## Access Compliance Report Public Rights-of-Way (Curb Ramps)

Intersection ID: 13696 Main Street: S\_KINGS\_DR Cross Street: E\_3RD\_ST Location: E

ADA ID: 7AB723B0A1C3 Ramp Type: PerpDiag Initial Pass/Fail: Fail Overall Compliance: No Severity Score: 36.25

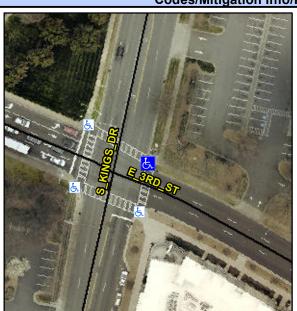
Not Found, R304.5.1, R304.5.3

Compliance Description Da		Data	Comp	liance	Description	Data
N/A	Ramp Length (in)	56.5	Yes	Ram	Slope (%)	6.7
No	Ramp Width (in)	25.5	No	Ram	XSlope (%)	2.6
N/A	Flare Type LT	N/A	N/A	Flare	Type RT	N/A
N/A	Flare Slope LT (%)	N/A	N/A	Flare	Slope RT (%)	N/A
N/A	Flare Traversable LT?	N/A	N/A	Flare	Traversable RT?	N/A
N/A	Landing Length (in)	N/A	N/A	DWS	Provided?	N/A
N/A	Landing Width (in)	N/A	N/A	DWS	Contrast?	N/A
N/A	Landing Slope (%)	N/A	N/A	DWS	Length (in)	N/A
N/A	Landing X Slope (%)	N/A	N/A	DWS	Full Width?	N/A
N/A	Landing Curb? (Y/N)	N/A	N/A	DWS	Offset (in)	N/A
N/A	Shared Landing?	N/A				
N/A	Gutter Ponding?	N/A	N/A	Gutte	er Slope (%)	N/A
N/A	Gutter Lip Ht (in)	N/A	N/A	Gutte	r X Slope (%)	N/A
N/A	Painted X Walk1?	Yes	N/A	Paint	ed X Walk2?	Yes
	X Walk 1 Direction	To NW		X Wa	lk 2 Direction	To SW
N/A	X Walk 1 Width (in)	95.0	N/A	X Wa	lk 2 Width (in)	95.0
	X Walk 1 Slope (%)	3.7		X Wa	lk 2 Slope (%)	1.1
	X Walk 1 X Slope (%)	2.1		X Wa	lk 2 X Slope (%)	1.9

Remove & Replace Curb Ramp With
Two New Directional Ramps or
Equivalent.
